**RE: 1035 Tropper Road
APN# 67-00-01540-004**

Reference: 1035 Trooper Road
Parcel No. 67-00-01540-004
"Trooper Ridge" Sketch Plan Review

RE: **Traffic Review #1 – Sketch Plan**
1035 North Trooper Road (S.R. 3002) – 48 proposed townhouse units
Worcester Township, Montgomery County, PA
Project No. 314086-01-001

TROOPER RIDGE
SKETCH PLAN EXHIBIT

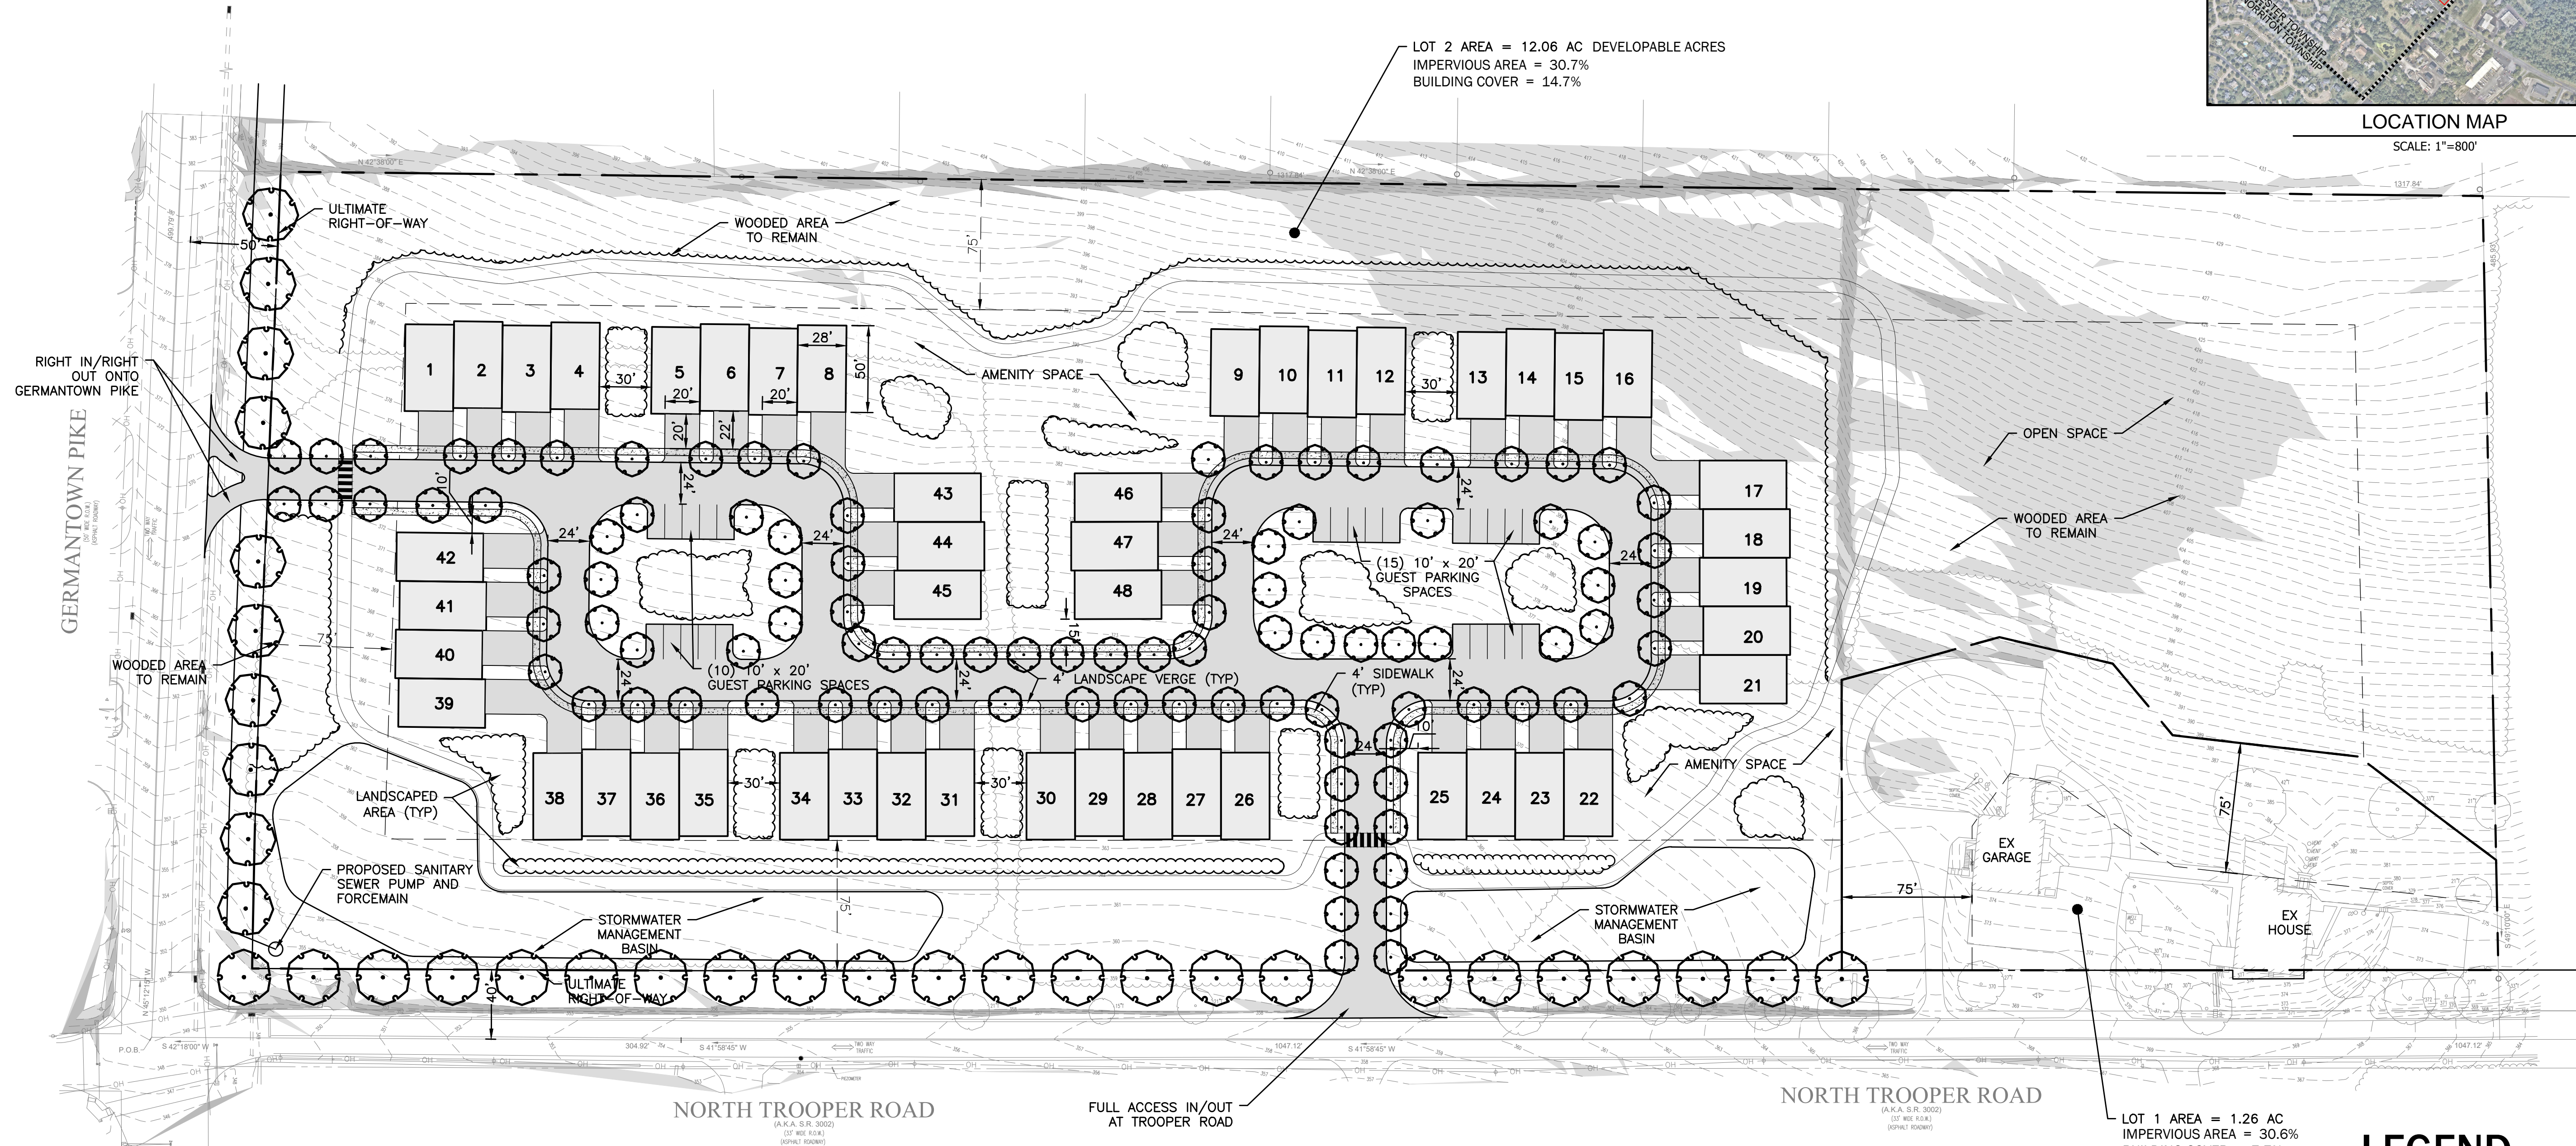
1. Ordinance No. 285 adopted June 16, 2021 made the MR Multi-Residential Overlay District applicable to this property with underlying zoning districts to remain. The existing 15.11-acre lot consists of two zoning districts, approximately 21% C-Commercial and 79% R-100 Residential. Once subdivided, Lot 1 will be entirely R-100 and Lot 2 will be approximately 19% C-Commercial with the remainder being zoned R-100 Residential. For clarity, the applicant should define the zoning district boundary on future plan submissions.

3. The proposed use of Lot 2, multi-family dwellings consisting of 48 townhouses, is permitted in the Multi-Residential District at a density of four units per developable acre. The plan notes a lot area of 12.06 acres; therefore, 48 townhouses is a permissible density only once the applicant provides a calculation demonstrating how the lot area was determined. The density may need to be reduced if the calculation returns a lesser lot area. (150-83.B and 150-89.E.1)

4. The applicant should confirm if the townhouses will be slab on grade or provide basements. All townhouses are limited to two stories and thirty feet in height. Due to the existing slope of the site, some units may have walk-out basements that could qualify as stories.

5. Two all-weather parking spaces are noted for each townhouse; the applicant should confirm if these spaces are to be located within a garage or if they will be located within the driveway area. If to be in the driveway, the typical paved driveway width must be dimensioned so that it may be confirmed two compliant spaces can be provided side-by-side. (150-9)

8. The plans show the conceptual stormwater management basins located in front yard setbacks. For multi-family residential districts, no part of any detention basin shall occupy more than 35% of the required yard area of any district yard. Additionally, no detention basin shall be located closer to any building containing two or more multi-family dwelling units than the minimum distance required between buildings. We note that a required 30-ft. separation is required between the stormwater facility and the townhomes. (150-89.D and 150-203)

9. No part of any detention basin shall be located 25 feet from any property line. (150-203)
10. The 75-foot unbuilt upon buffer strip between Lots 1 and 2 is not achieved in the vicinity of units 19 through 21. A variance will be required to place these units as currently shown on the sketch plan. Additionally, where homebuyers opt for a 10-foot patio or deck, this installation as described in Plan Note 1, will be an encroachment of the 75-foot buffer yard requirement at numerous locations throughout Lot 2. (150-89.E.6.a)

12. The required 130-foot sight triangle appears to be partially encroached by plantings. Clear sight triangles will need to be illustrated at intersections with Germantown Pike and Trooper Road on future submissions. (150-89.E.6.b.4)

- b. The portion of trail to the rear of proposed Lot 1 has a slope of approximately 14.67% and will disturb an existing wooded area. The applicant should consider minimizing impacts to existing wooded areas by re-routing the trail elsewhere as such a steep slope is not recommended for such a long segment. Preservation of natural resources, such as woods, is required in the overlay district. (150-89.E.3)

- d. Walking trails shall be 40 feet from property lines. The trail's proximity to the northwest corner of Lot 1 should be dimensioned. This narrow area may also prohibit the installation of a suitable landscape buffer between the remaining dwelling and new townhouses. (150-89.E.6.a)

18. All structures, buildings, parking areas, regraded slopes, and substantial improvements (with the exception of driveway and utility crossings when no other location is feasible) are prohibited on slopes of 25% or greater. It appears that construction of units 12 through 17 may impact steep slopes of 25% or greater; therefore, a variance would be necessary for their current location. (150-146.4.B.1)

24. The driveway configuration at units 16/17 and 38/39 is not recommended as this may encourage parking in the shared center section of pavement which is too small to properly accommodate a vehicle. This design may also result in unnecessary conflict points between driveway users. These clusters of townhouses should be reduced to have one less unit.

31. The applicant must be confirmed. The plans list Bristol Ridge Associates, LLC while the Application lists Commerce Pursuit Capital, L.P.
32. Note 5 under the site statistics must be revised to state R-100 zoning district.

4. The cartway widths along the North Trooper Road (S.R. 3002) and West Germantown Pike site frontages should be clearly labeled on the plan and be in accordance with **Section 130-16.C** of the **Subdivision**

7. According to **Section 130-18.A** of the **Subdivision and Land Development Ordinance**, sidewalk should be provided along the site frontages of North Trooper Road (S.R. 3002) and West Germantown Pike. The plan currently does not show any sidewalk along the North Trooper Road (S.R. 3002) and West Germantown Pike site frontages, thereby not satisfying the ordinance requirement. We recommend that the plan be revised to show sidewalk (or multi-purpose trail if preferred by the Township) along the entire site frontages of North Trooper Road (S.R. 3002) and West Germantown Pike. Otherwise, a waiver must be requested from this ordinance section. We do note that there is currently a multi-purpose trail provided around the perimeter of the townhouse units internal to the site. In addition, we also note to the Township at this time that no sidewalk currently exists along either side of North Trooper Road (S.R. 3002) and West Germantown Pike in the vicinity of the site. While again we recommend the provision of sidewalk and/or a multi-purpose trail on the plan, the Board of Supervisors may also consider deferring this obligation that is required of the applicant until such a time as may be required by the PennDOT, Montgomery County, or the Township for this property, whether under present or future land ownership, and at no cost to Worcester Township, or may desire to consider a fee in lieu of sidewalk to be kept in escrow for future sidewalk installations in the Township and/or area of these properties.

8. According to **Section 130-18.B** of the **Subdivision and Land Development Ordinance**, curbing should be provided along the site frontages of North Trooper Road (S.R. 3002) and West Germantown Pike. The plan currently does not show any curbing along the North Trooper Road (S.R. 3002) and West Germantown Pike site frontages, thereby not satisfying the ordinance requirement. We recommend that the plan be revised to show curbing along the entire site frontages of North Trooper Road (S.R. 3002) and West Germantown Pike, or a waiver must be requested from this ordinance section. We do note to the Township that there is currently no curbing along either side of North Trooper Road (S.R. 3002) and West Germantown Pike in the immediate vicinity of the site. Alternatively, the Board of Supervisors may also consider deferring this obligation that is required of the applicant until such a time as may be required by the PennDOT, Montgomery County, or the Township for this property, whether under present or future land ownership, and at no cost to Worcester Township, or may desire to consider a fee in lieu of curb to be kept in escrow for future curb installations in the Township and/or area of these properties.

12. Parking along the internal roadway curblines based on the site design, road widths and location of driveways should be prohibited by signing. The amount of guest parking spaces must be confirmed with the ordinance so that sufficient spaces are provided without the ability to park along the roadways. The applicant and designer may consider widening the western side of the internal road between lot 45 and lot 48 to a minimum of 28 feet to allow parallel parking along that section of road only.
